Plan Change 58
Avenue Business Park

Integrated Transport Assessment
October 2022

Plan Change 58: Avenue Business Park
Response to Council Traffic Feedback

This letter responds to a letter dated the 9th December 2022 from Matamata Piako District Council providing feedback and response on the Avenue Road Plan Change (PC58) draft application.

Figure 2: Stage 1 right turn bay effects

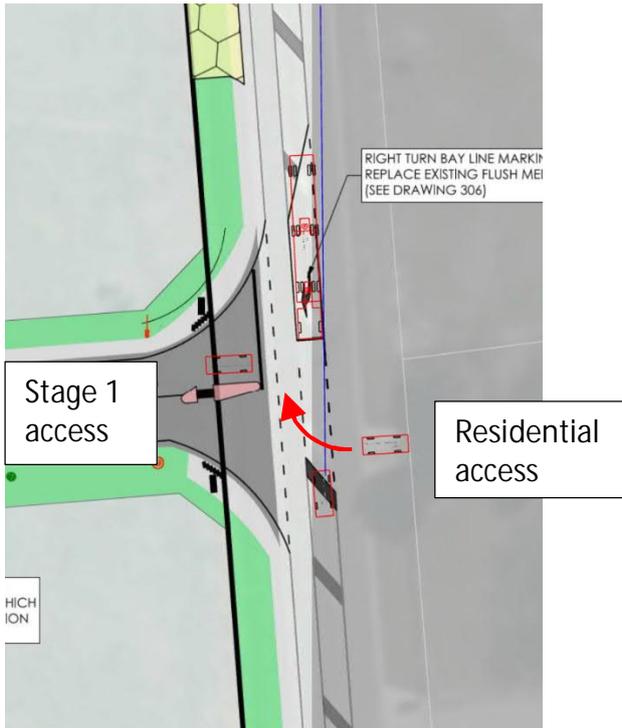
3. Provide an assessment of effects of additional traffic using the right turn bay within the flush median on Avenue Road North. The assessment needs to consider effects on the vehicle crossings located on the opposite side of the road.

The District Plan requires accesses to be located 30m from an intersection. Adjacent accesses on Avenue Road North within 30m of the Stage 1 intersection consist of a residential access 7m to the south of this intersection.

The predicted 95% queue length in the right turn bay with PC58 traffic is a maximum of 1.8m in the am peak period, with average delays of 5.9 seconds (data from the ITA). While traffic turning right out of the residential access will occasionally need to wait for right turn in PC58 traffic, the predicted queue length and delay shows that queued traffic is expected to have a relatively minor impact on this movement. The right/left stagger of these crossing places puts the right turn out movements from both sites in conflict with each other.

Figure 6: SH26 connection lane Level of Service

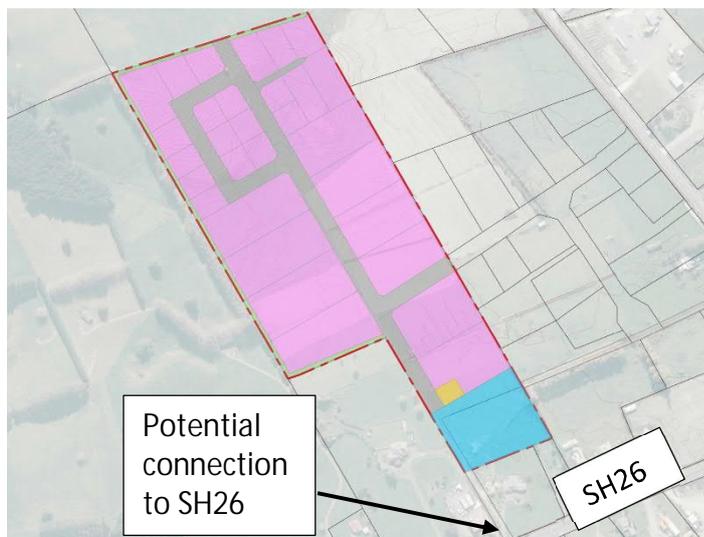
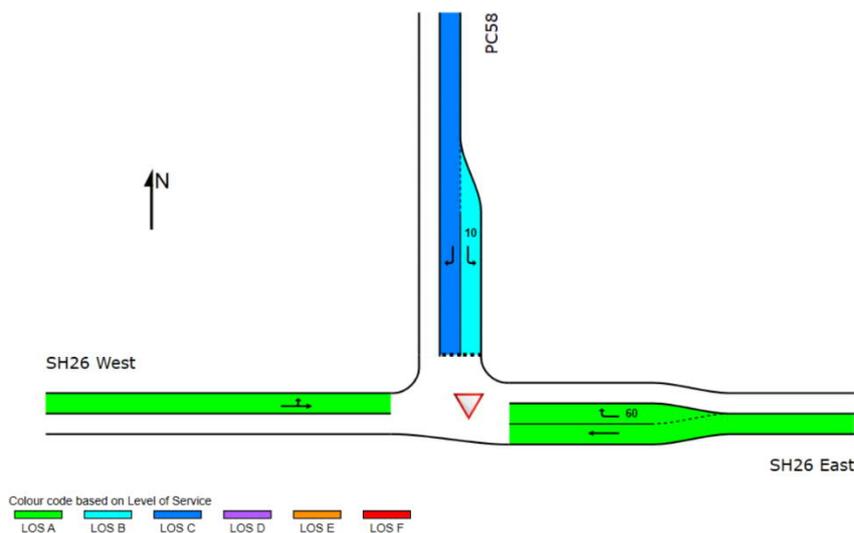
5. Provide an assessment of how direct access to SH26 could be provided in the future including consideration of appropriate intersection form on SH26.

A direct SH26 connection would reduce travel times for PC58 traffic wishing to travel to the west, and would improve integration with the state highway network. However, these benefits are not considered to outweigh the impact on state highway traffic associated with such a connection, particularly given that all PC58 traffic can be accommodated by the Avenue Road North intersection. A connection to SH26 would affect efficiency on the state highway, and would therefore be undesirable to NZTA unless there was good justification for such a connection. Justification for such a connection could be capacity issues at the Avenue Road roundabout, or to support further development which could not be accommodated via the Avenue Road North roundabout.

A new SH26 intersection is therefore only likely to be constructed in future if it is required to provide access to other land west or north of the PC58 site (subject to zoning changes) or if a roading connection is progressed by MPDC between SH26 and Hangawera Road.

A basic SIDRA assessment of a priority intersection at this location indicates that it would operate satisfactorily, with a Level of Service of C, maximum average delays of 15 seconds and a maximum degree of saturation of 47%. The inputs to this assessment are listed below, and the SIDRA movement summary sheet is attached to this letter.

The use of turning restrictions at a SH26 connection could also be considered. Right turn out movements could be directed to the Avenue Road roundabout, approximately 470m east of the SH26 connection. This would significantly improve the capacity of such an intersection and reduce effects on the state highway.

Although the intersection is not required for access for PC58, there are no obvious transportation reasons why the intersection could not be provided if it is required in future. Amendments have been made to the Avenue Business Park Development Area Plan (ADAP) to identify a 'Potential Future Vehicle Connection to SH26' and to ensure that a future roading corridor is retained west of the stormwater management reserve (see response to point 9).

Figure 8: Flow diagrams for 35% of traffic to/from the north

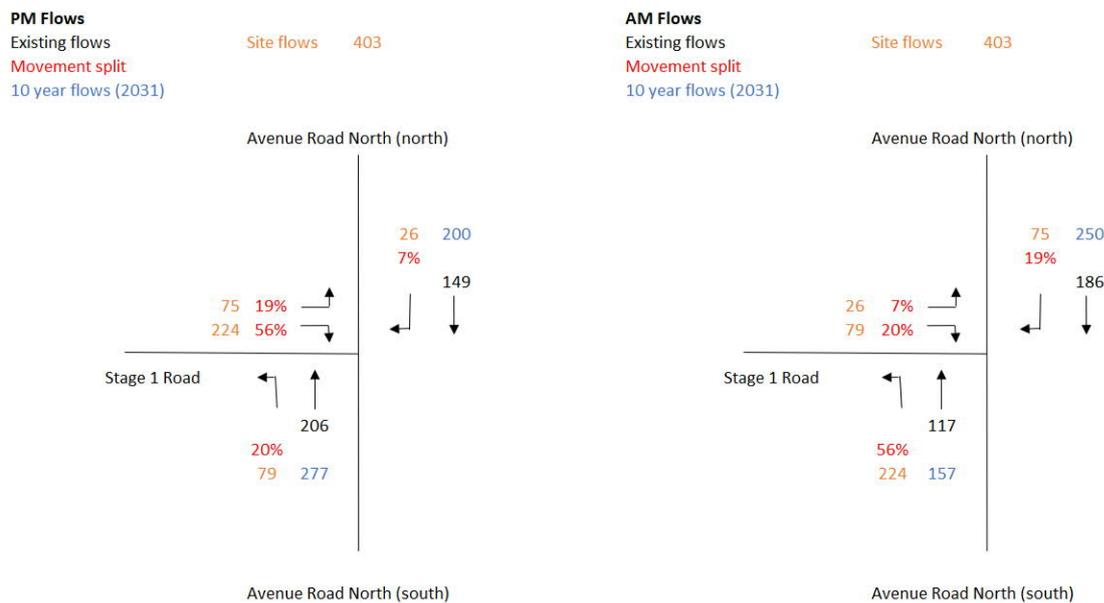
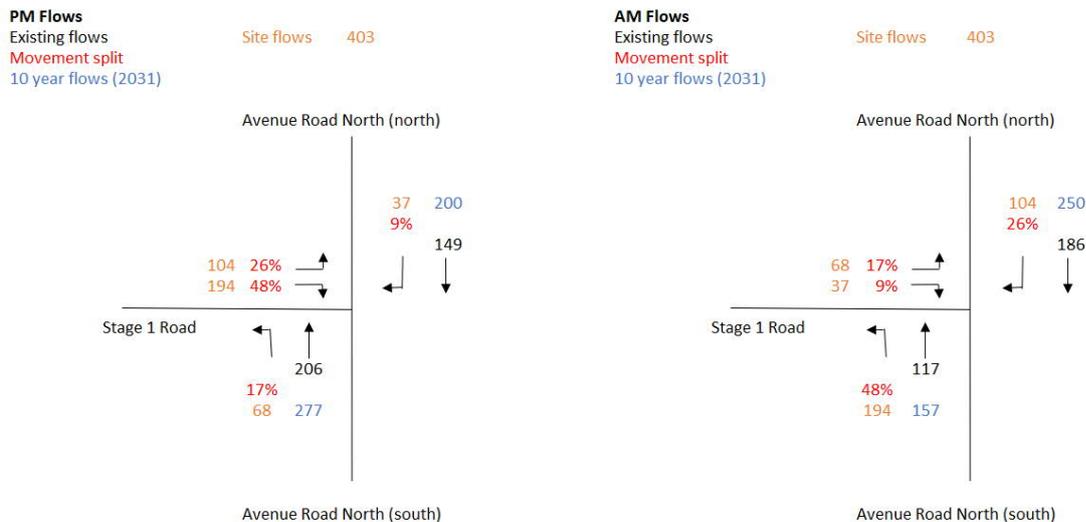
6. Provide a sensitivity assessment of the proposed trip distribution to capture future trips to and from the north once residential activities are further established (i.e. Lockerbie Plan Change).

The flow diagrams and capacity assessments in the ITA used a directional split of 25:75 to the north:south. This was based on flows from a nearby intersection (Keith Camp Place).

A sensitivity assessment has been undertaken in this letter for a directional split of 35:65 to the north:south at the Stage 1 intersection with Avenue Road North. This directional split is expected to appropriately account for traffic from the Lockerbie Plan Change and other residential developments to the north of the site. The SIDRA results for this assessment show that the intersection will operate satisfactorily with 35% of traffic travelling to/from the north. This scenario resulted in improved capacity compared with the 25:75 split, as the number of right turn out movements is decreased. The 35:65 split assessment has a maximum degree of saturation of 20%, maximum average delays of 5.9 seconds, and a Level of Service A. The 25:75 directional split has been used in the remainder of this letter, as the more conservative assessment.

Figure 10: Crash locations on Snell Street

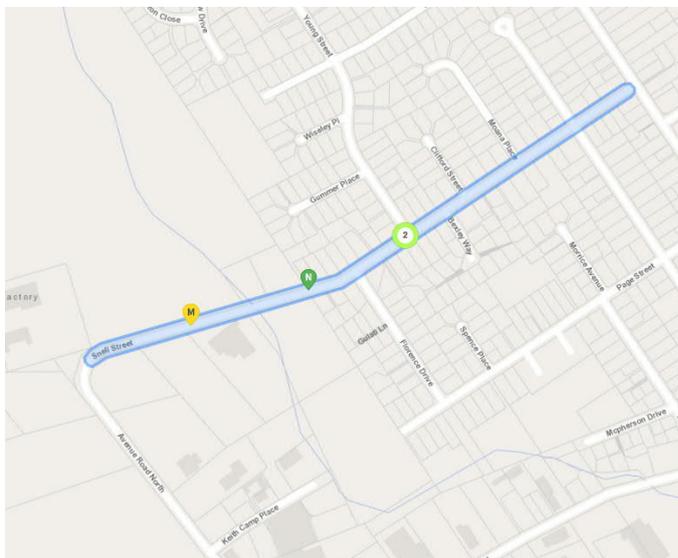
7. Provide a detailed assessment of the effects on the surrounding road network including but not limited to Avenue Road North, Snell Street, Snell Street/Studholme Street intersection. The assessment should identify any potential safety or efficiency effects including effects as a result of additional heavy traffic on the surrounding road network and if mitigation is required to ensure that the network operates safely.

CAS shows that there have been four crashes on Snell Street in the last five years. Two crashes occurred at the Young Street Intersection, and two crashes occurred at the west end of this road. The two crashes at Young Street included one turning crash and once crash where a vehicle swerved to avoid a pedestrian. The two crashes at the west end of the site were both loss of control crashes, with one of the crashes resulting in a minor injury. The crash history indicates a pattern of loss of control crashes in the 70 km/h length of Snell Street. Making all of Avenue Road North and Snell Street 50 km/h would help address this matter. This change in the posted speed limit is a matter for Council to consider. The lack of pedestrian crossing facilities on Snell Street is also considered to be an existing matter to be considered by Council.

Figure 14: Stage 1 consented cross sections

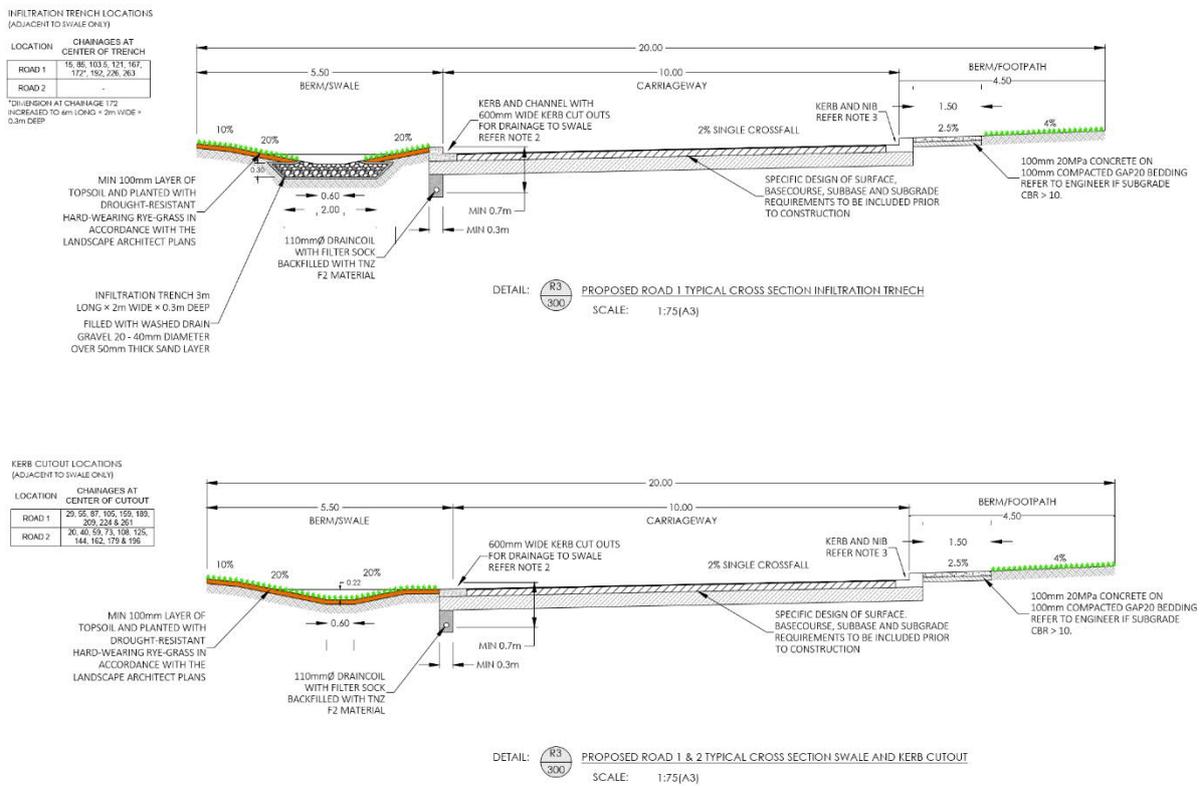
12. Update plan provisions to include proposed cross-sections, future road connections (i.e. to the west).

It is intended that the road cross sections will match that approved for Stage 1. Specific cross sections are not considered to be necessary given the design of roads will need to be in accordance with the Regional Infrastructure Technical Specifications (RITS) or any other relevant standard applying at the time.

Figure 15: Avenue Road North pedestrian assessment – Vowles Transport to Stage 1 intersection

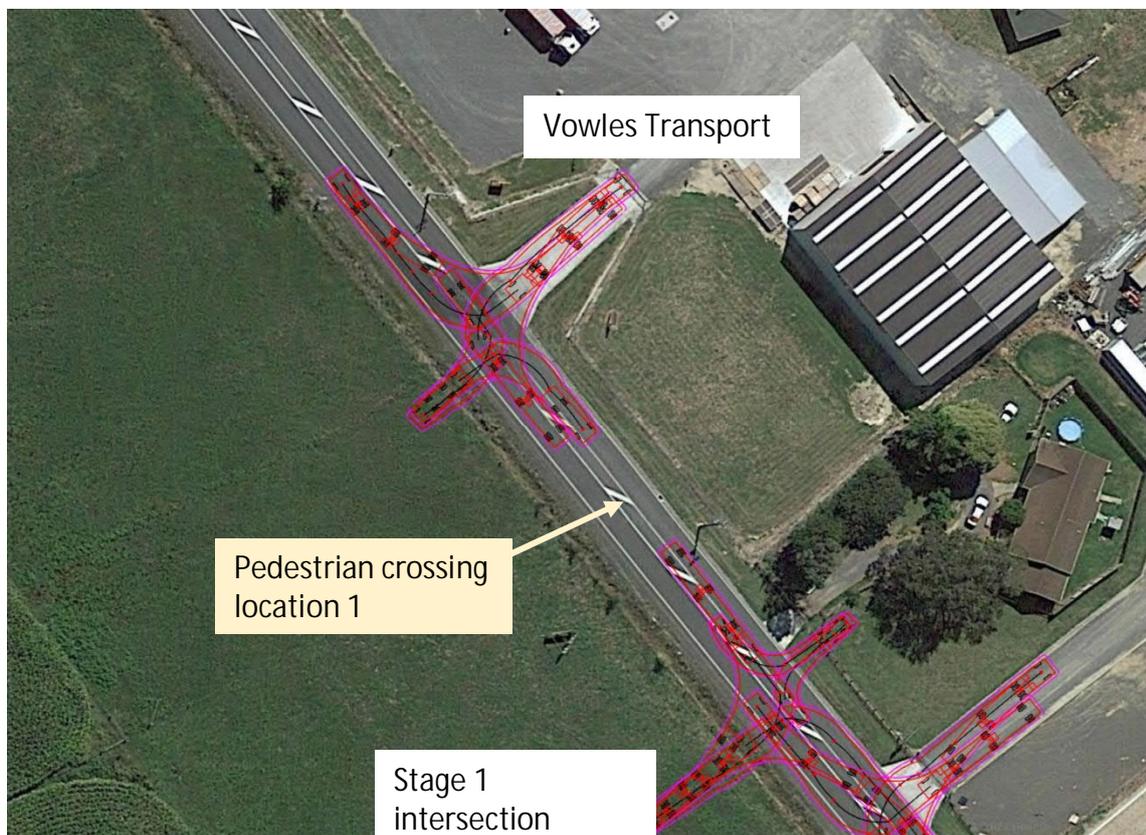
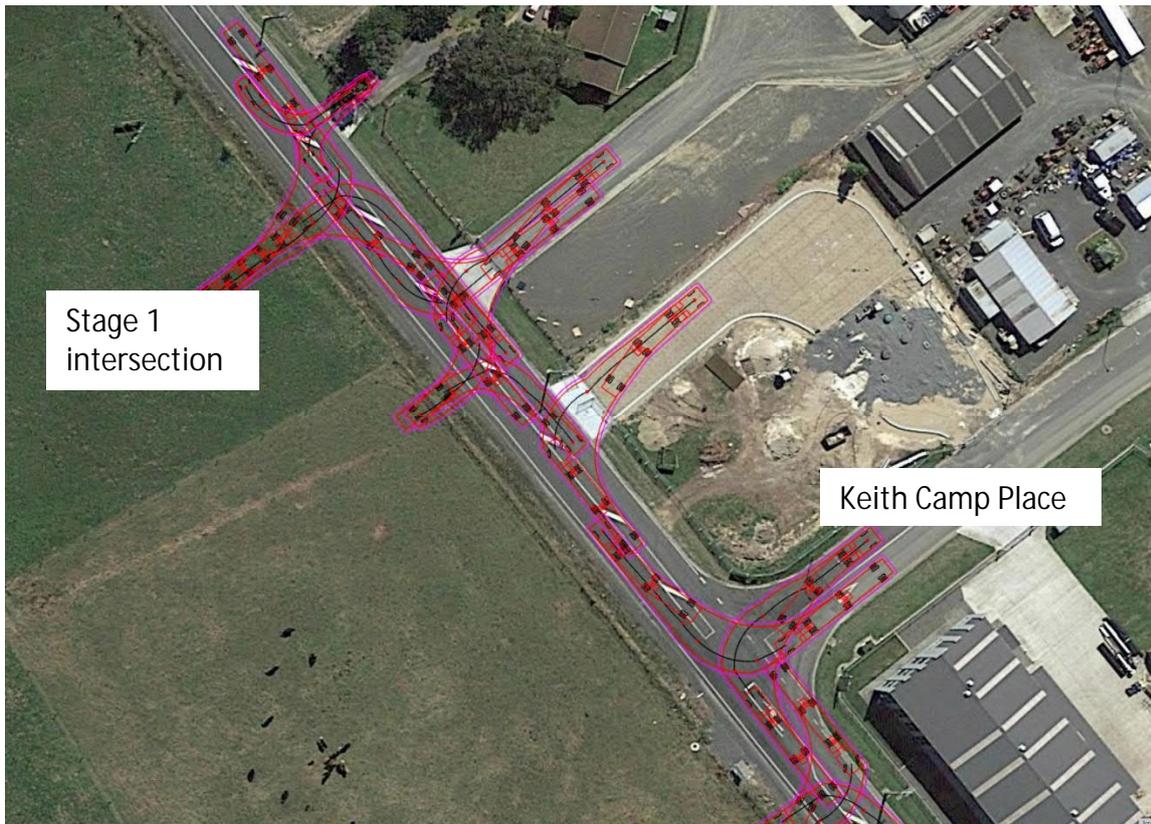
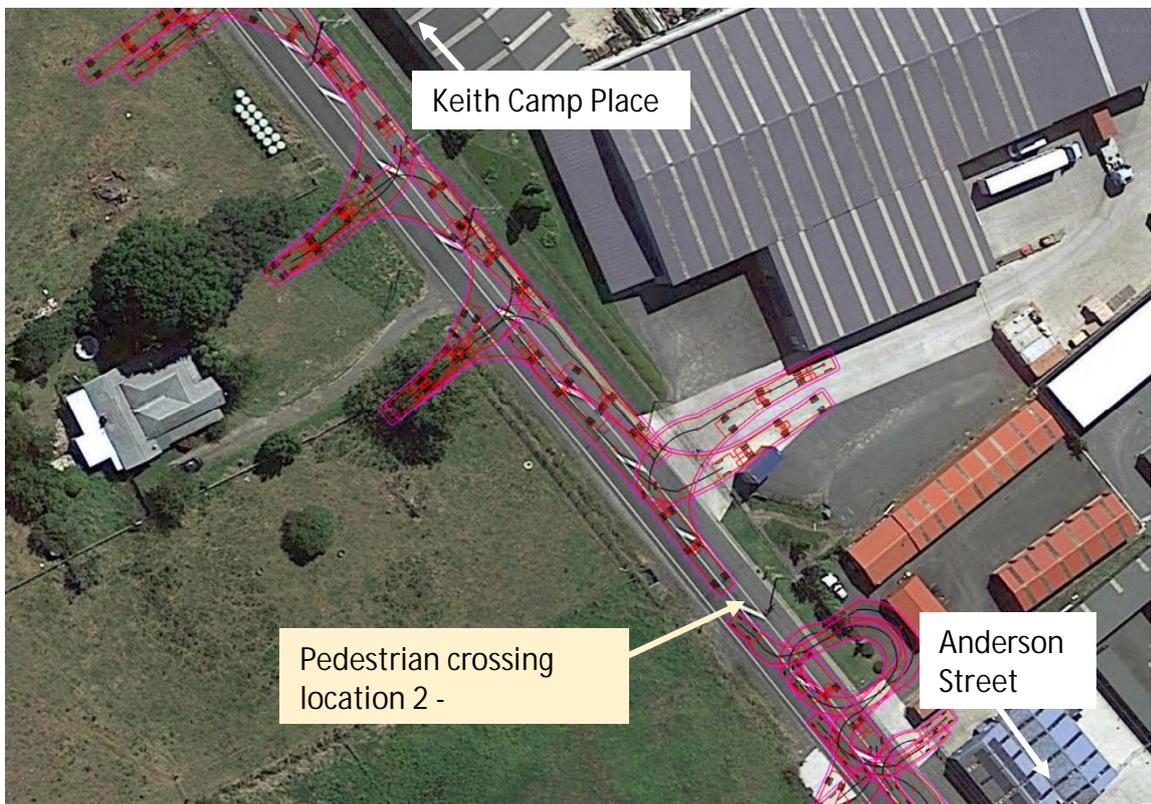
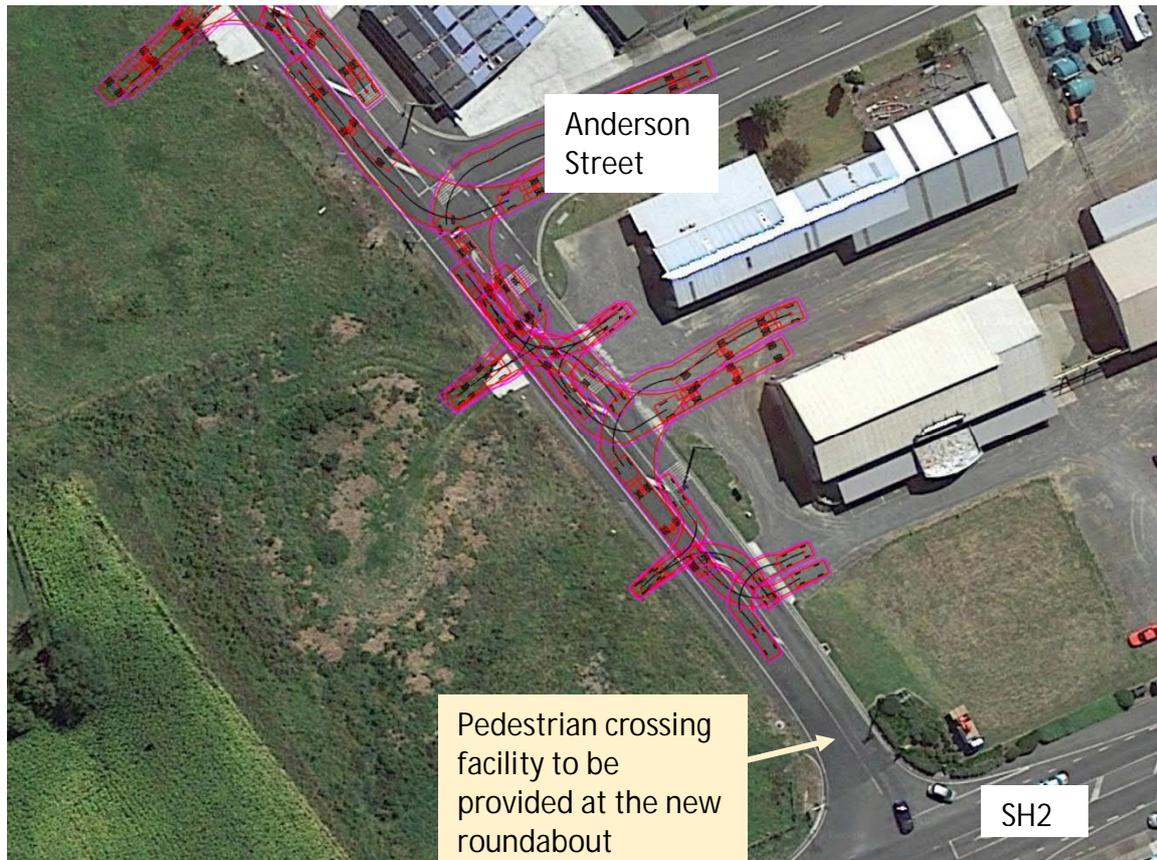
13. Provide an assessment of where a safe pedestrian crossing could be provided on Avenue Road North including an assessment of the appropriate crossing facility at this location including what environmental changes are required to support a safe crossing facility i.e. safer posted speed (noting that changes to speed will need to be implemented by the RCA).

Swept path diagrams for the pedestrian assessment are provided in Figures 15 to 18. These figures run consecutively from north to south.

The appropriate form for any pedestrian crossing facilities is a pedestrian refuge. This facility is a good compromise between improving pedestrian safety and minimising effects to traffic. The installation of a pedestrian crossing facility is only recommended in areas with a 50 km/h posted speed. Both recommended crossing locations are in 70 km/h areas, with the 50 km/h posted speed limit located just north of Anderson Street, extending to the south. It is therefore recommended that Council consider lowering the speed limit along all of Avenue Road North and Snell Street to 50 km/h prior to the construction of these crossing facilities. If the speed is reduced and if locations 1 and 2 are confirmed to be suitably clear of swept paths then it is expected that pedestrian refuges can be easily installed on the 2m wide flush median on Avenue Road North.
